ADDENDUM NO. 03

June 21, 2024

Additions and Renovations to Franklin Central High School Phase 2B
6215 S. Franklin Rd.
Indianapolis, IN, 46259

THICKENED SLAB DETAIL

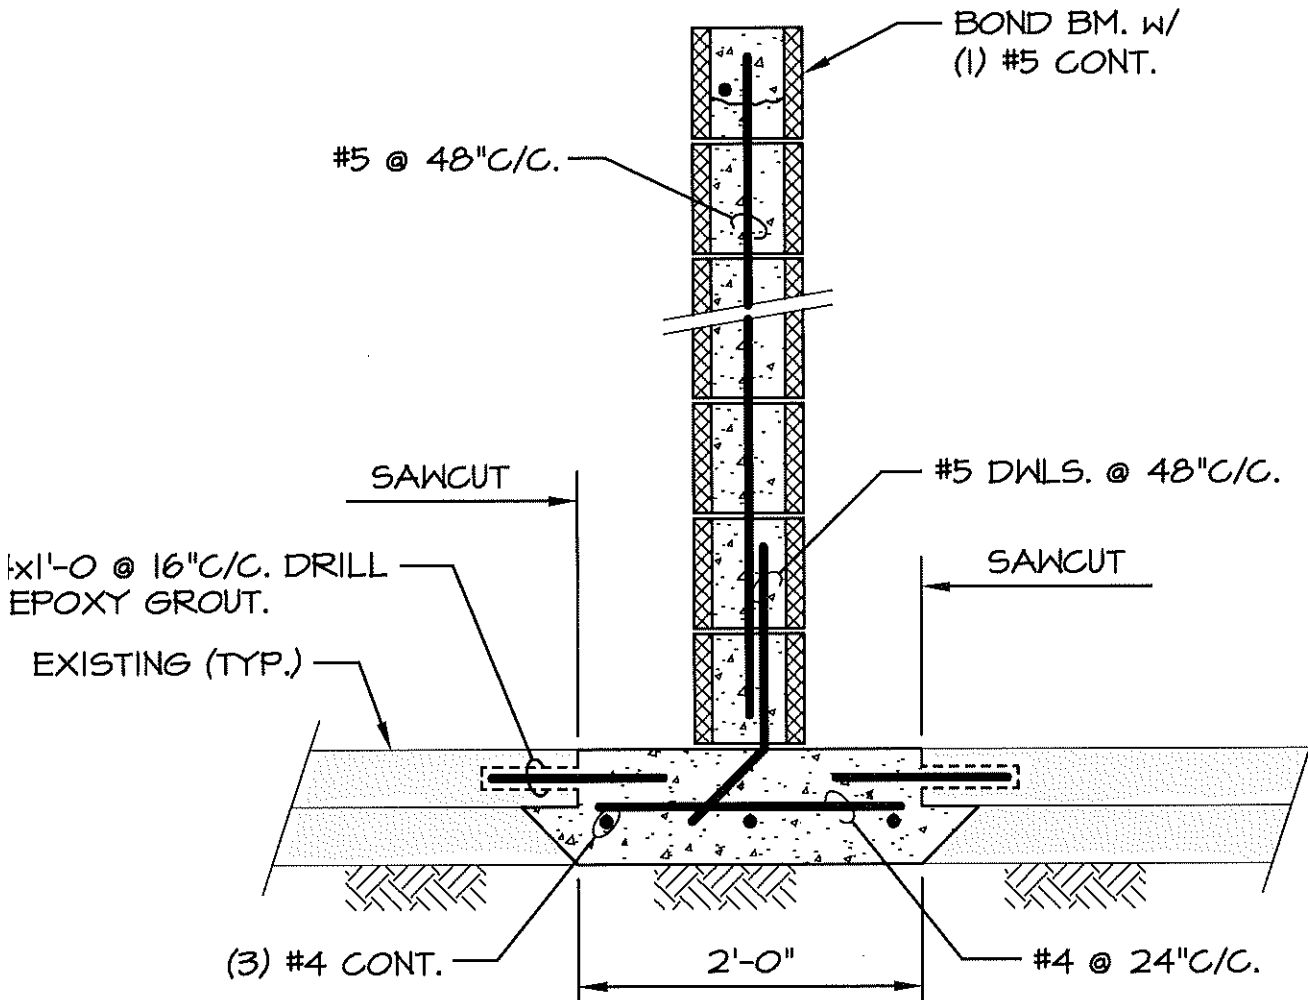
- 16. Responsible for thickened slab work per attached sketch.
- 17. Provide hardware for aluminum doors to BC#7.
- 18. Responsible for Note #3 Sheet FS1.3.
- 19. Responsible for wood on Details 2/2A/3 on Sheet A103.

Clarification Walls that are less than 10'-8" tall do not require reinforcing and thickened slab. See Architectural drawings for wall locations and heights.

CONCRETE STOOP DETAIL

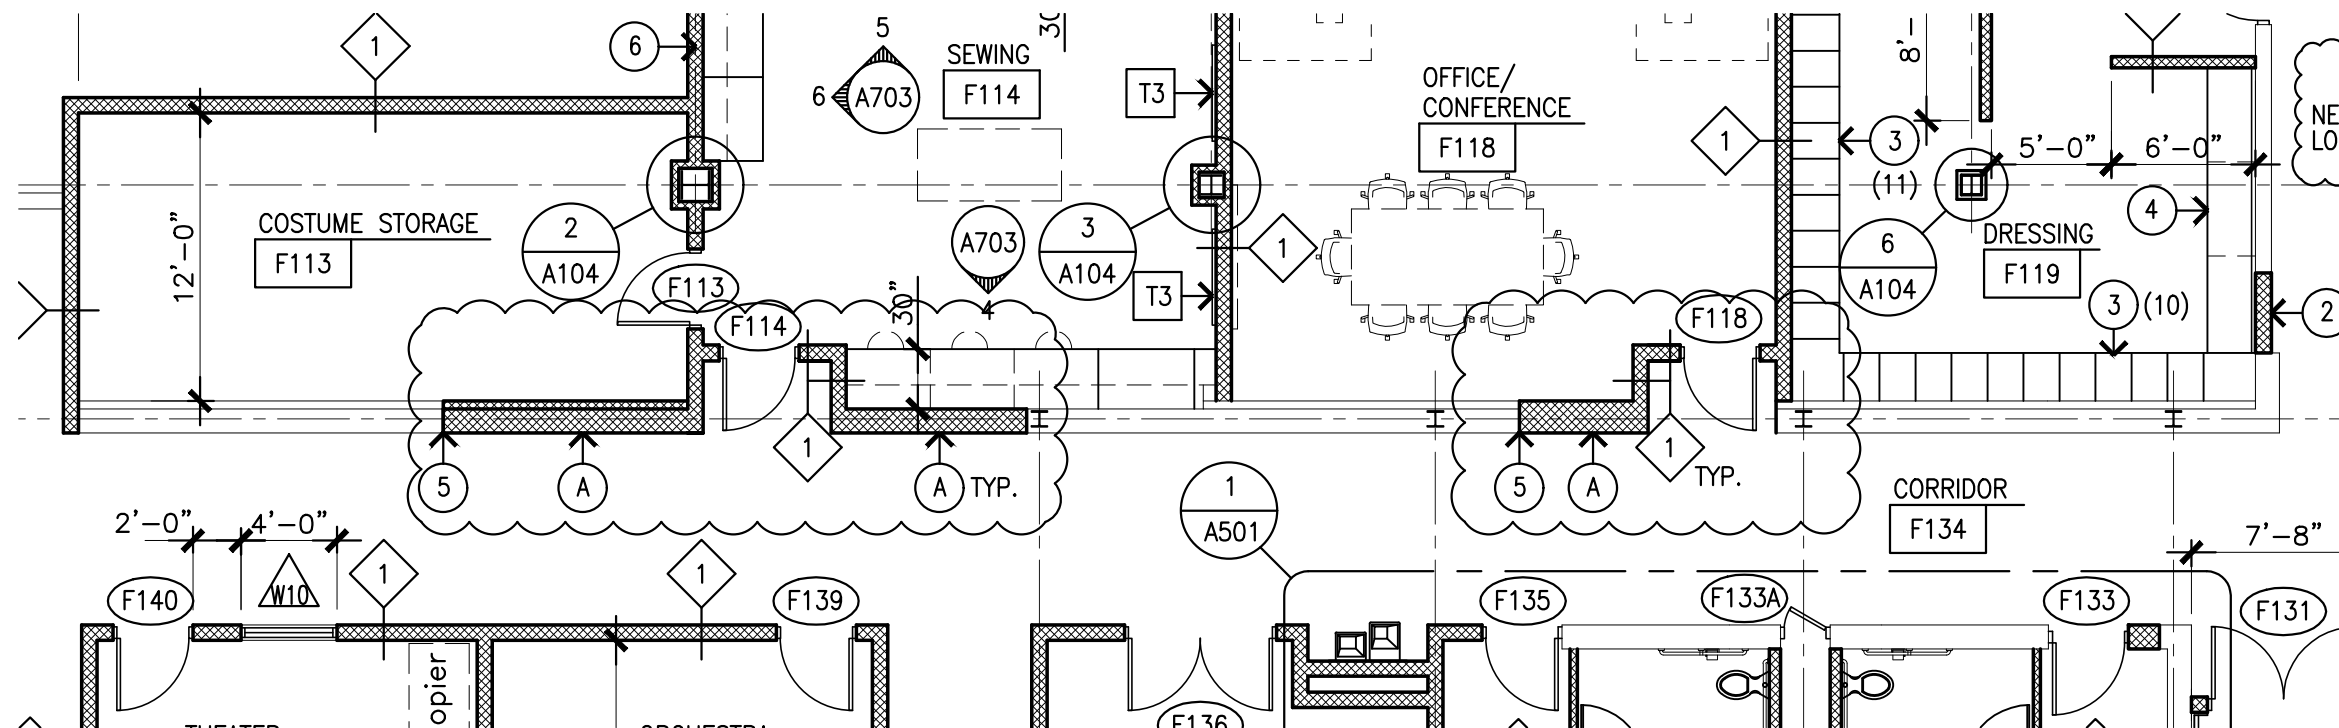
3-24 C250: Plan Note 5, Flush Concrete Stoop, shall be as indicated on attached sketch, ADD3-SK1.

1. CONCRETE STOOP DETAIL, AS REFERENCED ON SHEET C250, SITE IMPROVEMENT PLAN, PLAN NOTE 5.

1
A110 **SECOND FLOOR PLAN - UNIT U**
SCALE: 1/16" = 1'-0"

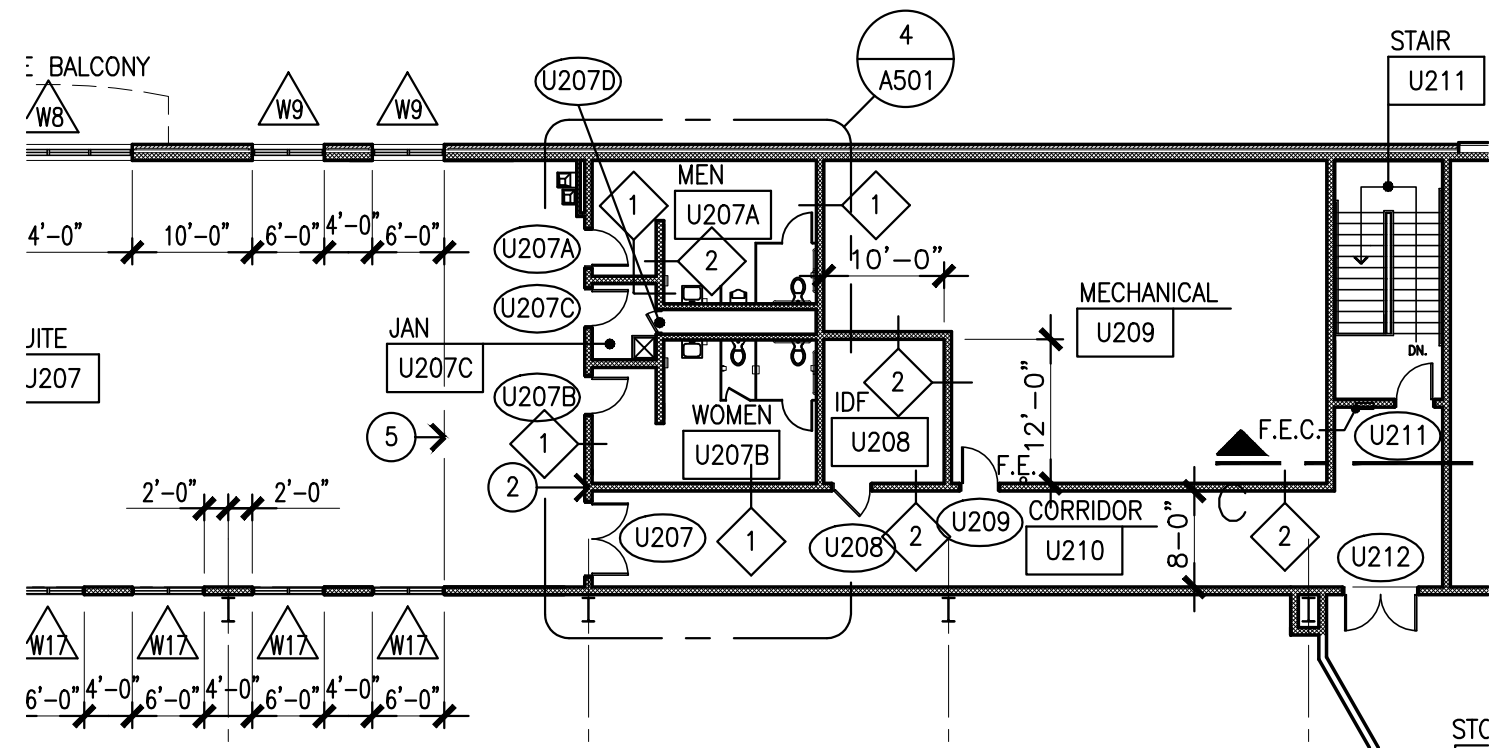
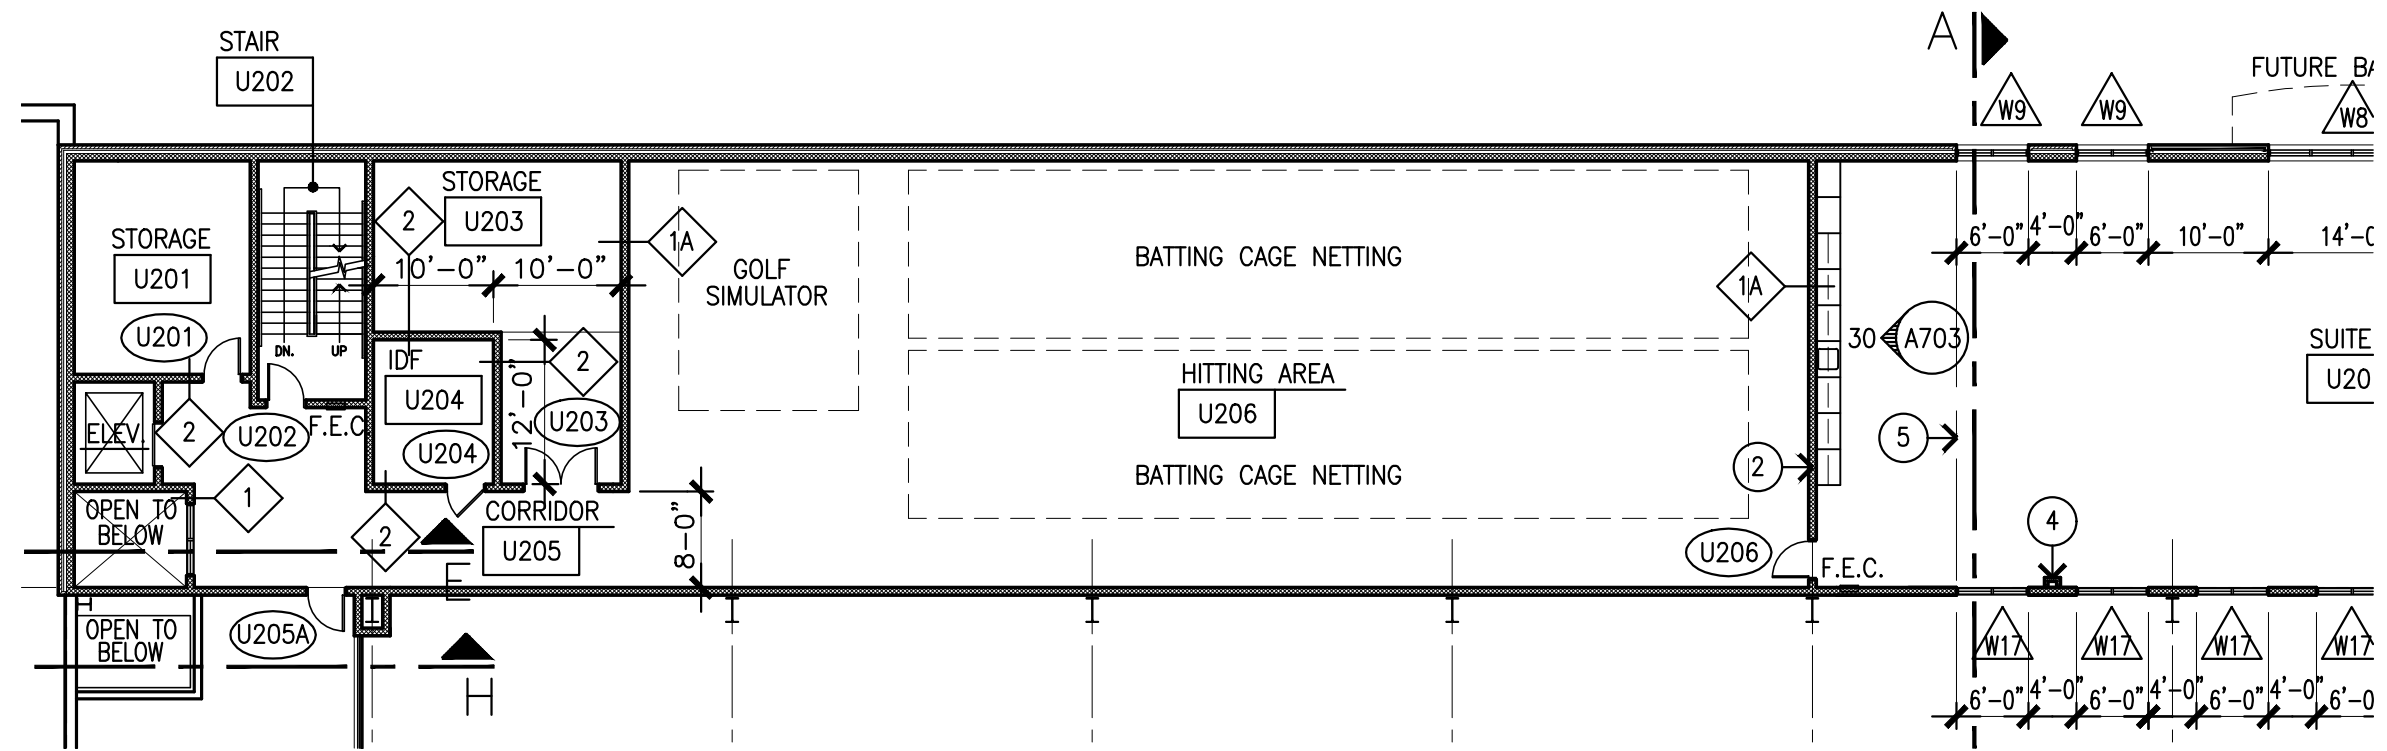
- 3-31 Refer to attached sketch, ADD3-SK3 for Wall Type information at Unit U, Second Floor.
- 3-32 A604: Add Type A Locker Elevation as indicated on attached sketch, ADD3-SK4.

GENERAL NOTE:
1. SEE ADDED WALL TYPES AS NOTED.
